E5071C-54

Modification Recommended Service Note

E5071C ENA Series Network Analyzer, 9 kHz to 20 GHz

E5071C SSD SATA Cable Installation Enhancement for Fixed Data Storage (Opt-019)

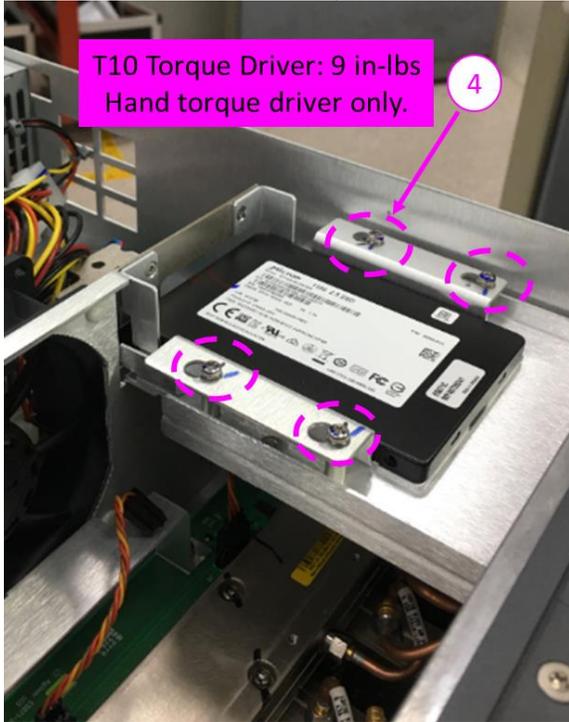
1. Remove the E5071C casing. Refer to service guide chapter 6 – Outer Cover Removal.
2. Remove the SSD assembly.
3. Install the angle as depicted. Fasten the two screws.

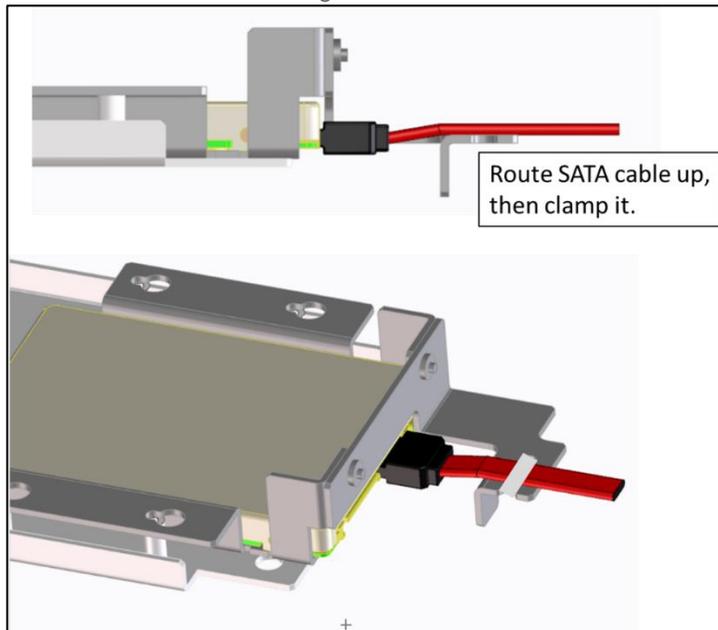
4. Reinstall the SSD assembly to the E5071C chassis.

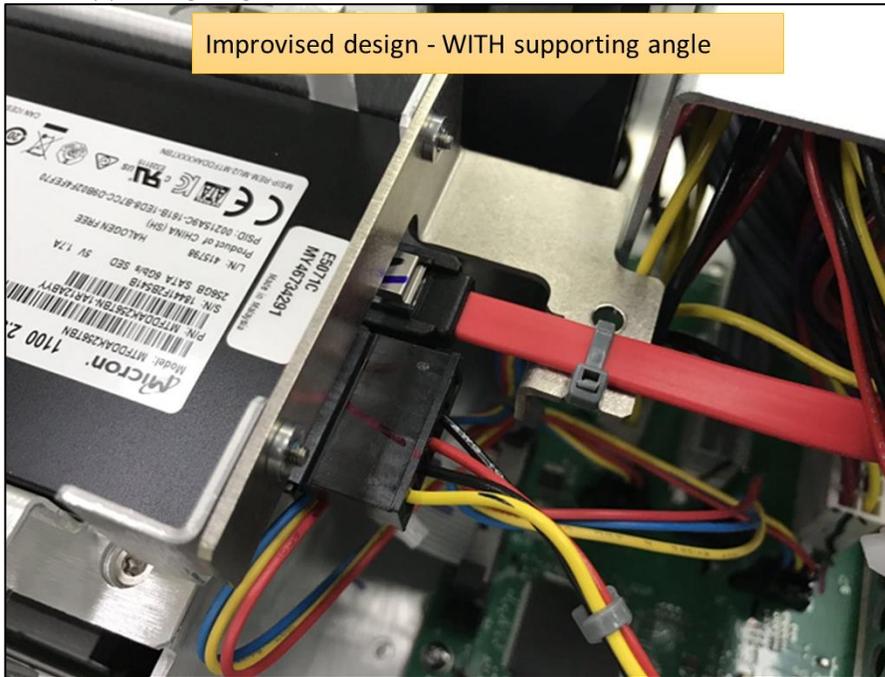
5. Connect the SATA cables and power supply cable.
The SATA cable needs to be lifted **upward** and supported by the angle. Shown is the illustration on the SATA cable routing.

- Apply cable tie to secure the SATA cable onto the angle. Shown is the E5071C SSD assembly with supporting angle. Ensure the cables are well-fastened.
